Master Plan Amendment #2019-0001

Issue: Consideration of a request to amend the Landmark/Van Dorn Small Area Plan chapter of the Master Plan to amend the Landmark/Van Dorn Corridor Plan Overlay and incorporate a new Landmark Mall Chapter as an addendum.	Planning Commission Hearing:	April 2, 2019
	City Council Hearing:	April 13, 2019
Staff: <i>Planning and Zoning</i> : Karl Moritz, Director; Jeffrey Farner, Deputy Director; Carrie Beach, Division Chief; Katherine Carraway, Urban Planner; Ashley Labadie, Urban Planner; <i>Transportation and Environmental Services</i> : Yon Lambert, Director; Christopher Ziemann, Division Chief; Melanie Mason, Watershed Management Planner; Megan Oleynik, Urban Planner; <i>Recreation, Parks and Cultural Activities</i> : Jack Browand, Division Chief, Park Planning; <i>Housing</i> : Helen McIlvaine, Director; Brandi Collins, Housing Planner.

Figure 13: Land Use

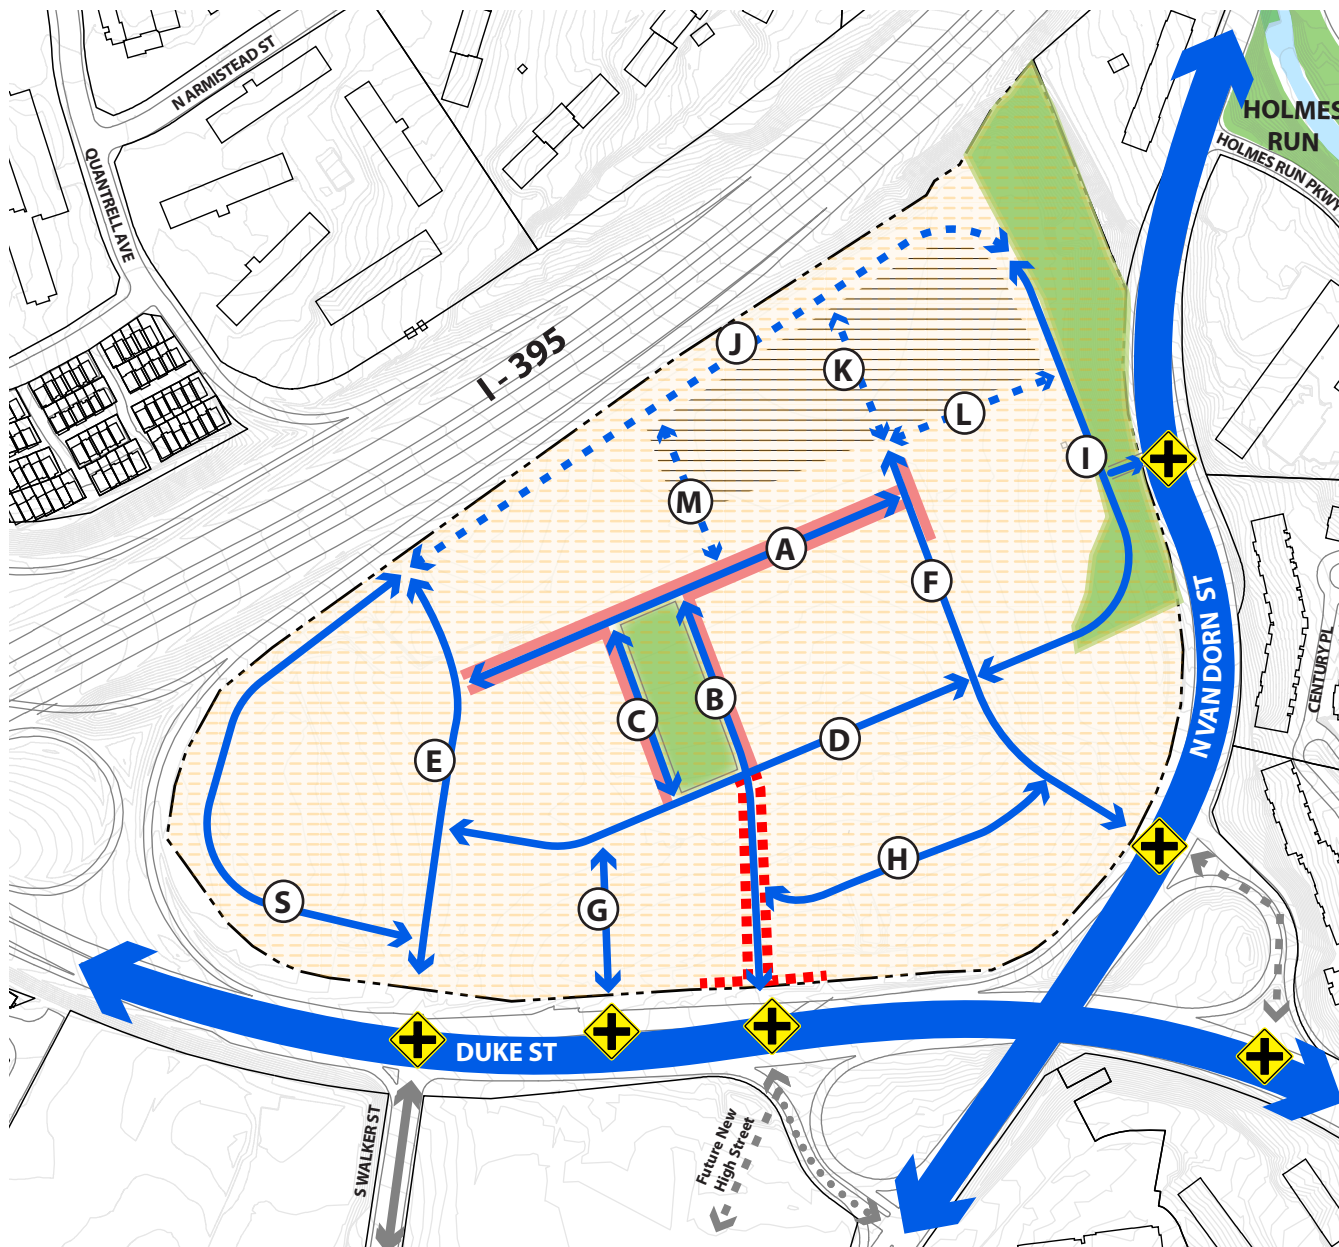
10.3.1 Permit the flexibility of allowable uses across the neighborhood with a maximum development of 5.6 million square feet, exclusive of community facilities and existing above grade parking structures as generally depicted in Figure 13. A minimum of 20% of the total development is required to be non-residential uses (such as office, hotel, retail, personal service, and hospital), ~~in addition to the amount of commercial use for the required active retail locations as general depicted in Figure 13.~~ The required active retail, as depicted in

Figure 13, will be counted toward the 20% minimum, however, provision of 20% non-residential uses in other locations will not relieve the requirement for active retail.

10.3.3 In the required and preferred ground floor active retail locations depicted in Figure 13, provide ground floor minimum floor to ceiling height of ~~18~~ 17.5 feet and minimum depth of 30 feet and building design that engages the public realm through use of transparent windows and building articulation.
